**Tree Inventory, Assessment,
and
Protection**

**56 Central Avenue
Los Gatos, CA 95032**

Town of Los Gatos

October 11, 2018

Appendix A: Tree Inventory Map and Site Plan A1: West Portion

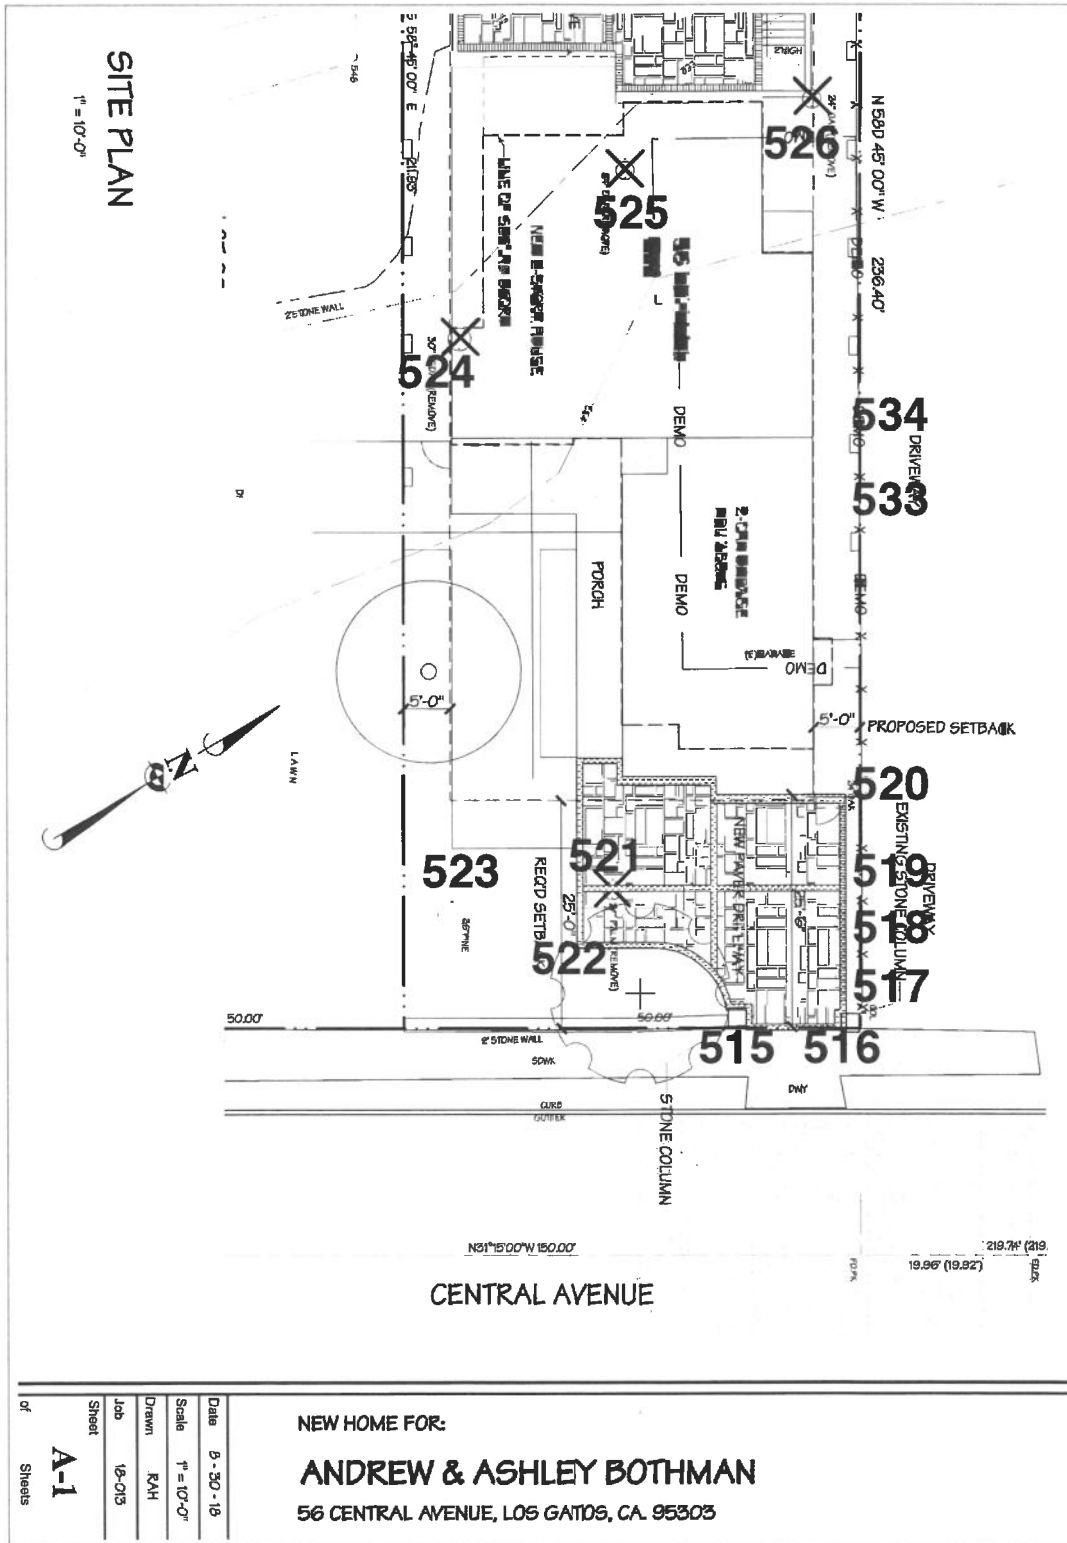
Coast live oaks 517, 518, 519, 533, 534 are not located on the plans and are growing along the property boundary adjacent to the existing cottage (Appendix A). Trees 517, 518, 519 are at the driveway entrance while 533 and 534 are next to the structure growing along the northeast boundary. It is likely these trees originate on the adjacent site along with blue oak 528 and coast live oak 529.

Several trees are indicated to be removed including date palm 521, deodar cedar 524, coast live oaks 525 and 526, and blue oak 527. All these trees are within the footprint of the proposed structures. Stone pine 523 is listed to remain on the site plan but removed on the civil drawings, it will be highly impacted by grading and any destruction to the soil environment or roots behind the lean will compromise the tree.

2. Locate and include trees 517, 518, 519, 533, 534 missing from the plans growing along the northeast boundary.
3. Contact a wildlife biologist to inspect the date palm and verify any protection required as per the Migratory Bird Treaty Act and State Regulations regarding birds of prey.
